MODIFICATION PROPOSAL FORM**WFPS REACTIVE POWER**

FORM GC1, PROPOSAL OF MODIFICATION TO GRID CODE.

WFPS1.6.3 REACTIVE POWER CAPABILITY

Figure WFPS1.4 – Minimum Reactive Power Capability of Controllable WFPS

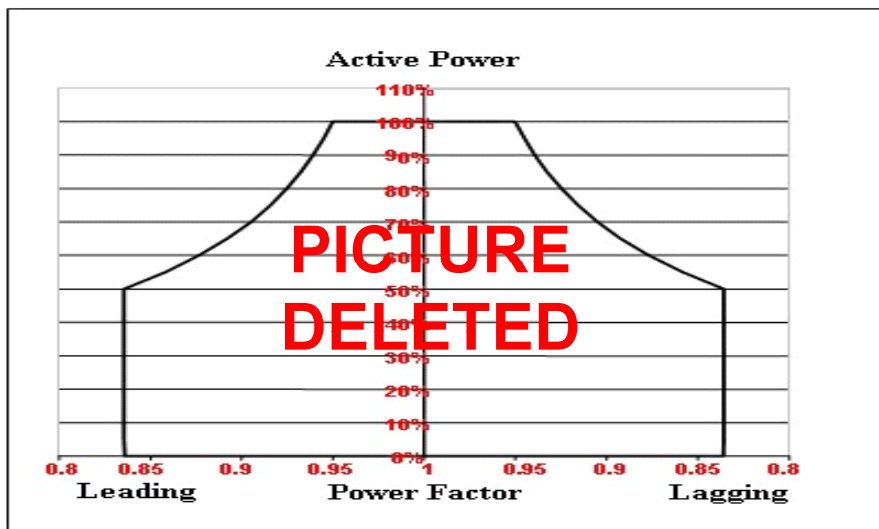
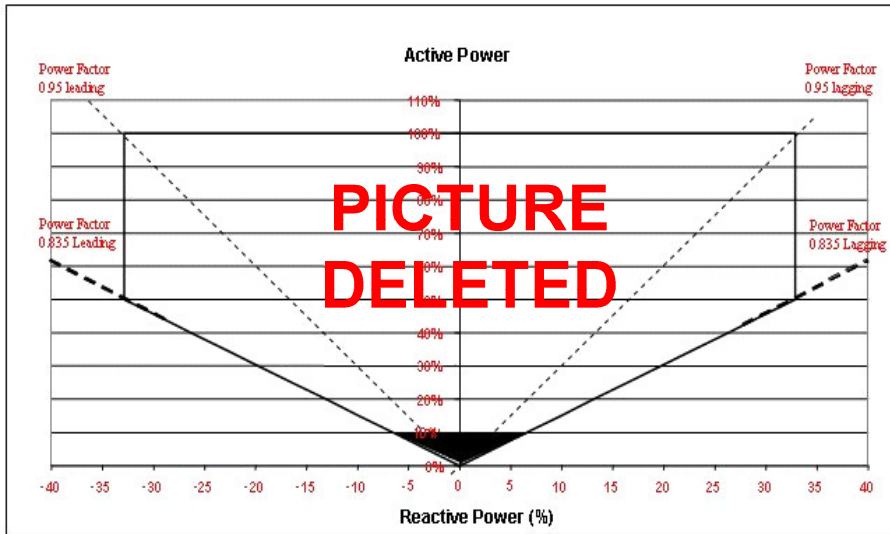
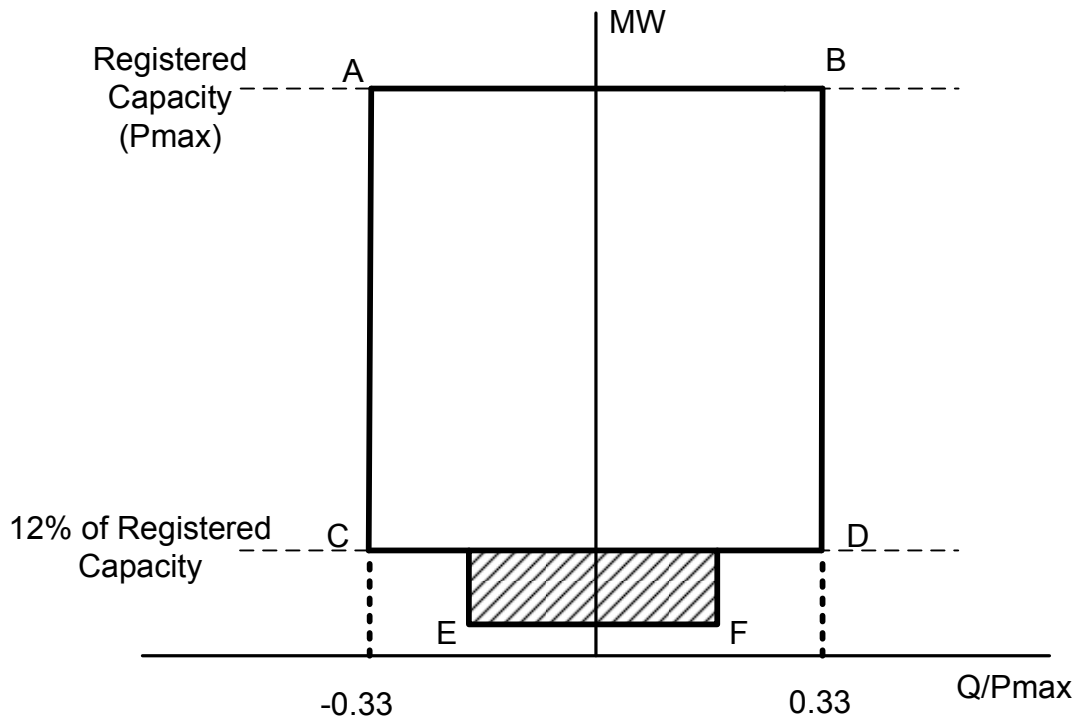
WFPS1.6.3.1 **Controllable WFPSs** operating in **Power Factor** control mode, Voltage Control Mode or Constant Reactive Power mode shall be at least capable of operating at any point within the P-Q capability ranges illustrated in *Figure WFPS1.4*, as measured at the **Connection Point**.

Point A represents the minimum Mvar absorption capability of the **Controllable WFPS** at 100% **Registered Capacity** and is equivalent to 0.95 power factor leading;

Point B represents the minimum Mvar production capability of the **Controllable WFPS** at 100% **Registered Capacity** and is equivalent to 0.95 power factor lagging;

Point C represents the minimum Mvar absorption capability of the **Controllable WFPS** at 12% **Registered Capacity** and is equivalent to the same **Mvar** as Point A;

Point D represents the minimum Mvar production capability of the **Controllable WFPS** at 12% **Registered Capacity** and is equivalent to the same **Mvar** as Point B;

Point E represents the minimum Mvar absorption capability of the **Controllable WFPS** at the cut-in speed of the individual **WTGs**;

Point F represents the minimum Mvar production capability of the **Controllable WFPS** at the cut-in speed of the individual **WTGs**;

The **TSO** accepts that the values of Points E and F may vary depending on the number of **WTGs** generating electricity in a low-wind scenario;

Figure WFPS1.4 represents the minimum expected reactive power capabilities of the **Controllable WFPS**. The **Controllable WFPS** is obliged to tell the **TSO/DSO** if it can exceed these capabilities, and submit the actual P-Q capability diagram based upon the installed plant and **Collector Network** characteristics to the **TSO** during **Commissioning**.

~~The design reference voltage for the **Reactive Power** capability shall be the nominal voltage at point Y.~~

The **Grid Connected Transformer** tap changing range must be capable of ensuring nominal voltage at point Y for any **Voltage** at the **Connection Point** (Point Z) within the ranges specified in WFPS1.6.1.
